**Errata Document**

A. This document details the limitations of the cascading option of the AD73360 due to a bug in the current silicon.

Figure 2. Cascade Timing for a Three-Device Cascade

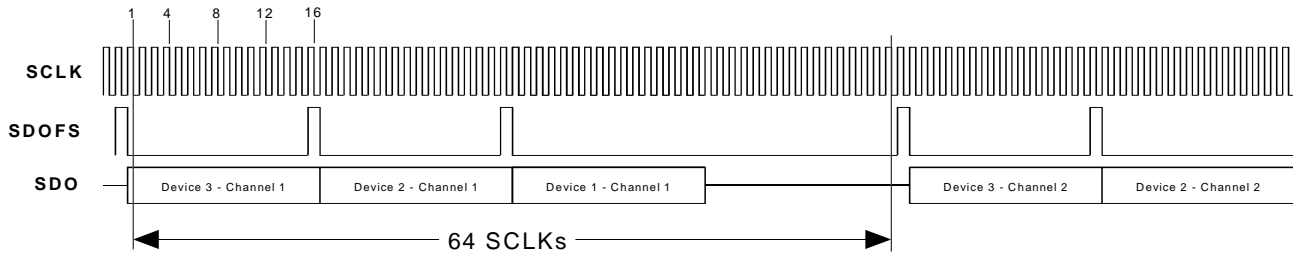
For cascades of more than two devices the AD73360 will leave too many SCLKs between transmitting channel information. This increases the time it takes to transmit the ADC data and since a DSP or microcontroller must read data from all the ADCs in the cascade in one sample period the number of devices which can be cascaded will be limited. Figure 2 shows the effect the additional SCLKs have on a cascade of three devices.

For a cascade of a given length, the SCLK rate and Sample Period will determine if the cascade can be used successfully. A low sample rate will allow more time for the ADC data to be read. Similarly a high SCLK rate will transmit the data in a shorter time. Since both the SCLK rate and Sample Rate are derived from the same DMCLK the number of combinations is limited. As most applications will require a predetermined sample rate, the SCLK speed will be the limiting factor in the cascade length that can be used. Table I shows the maximum cascade length for a given SCLK and Sample Rate. The table assumes that a MCLK of 16.384MHz is used.
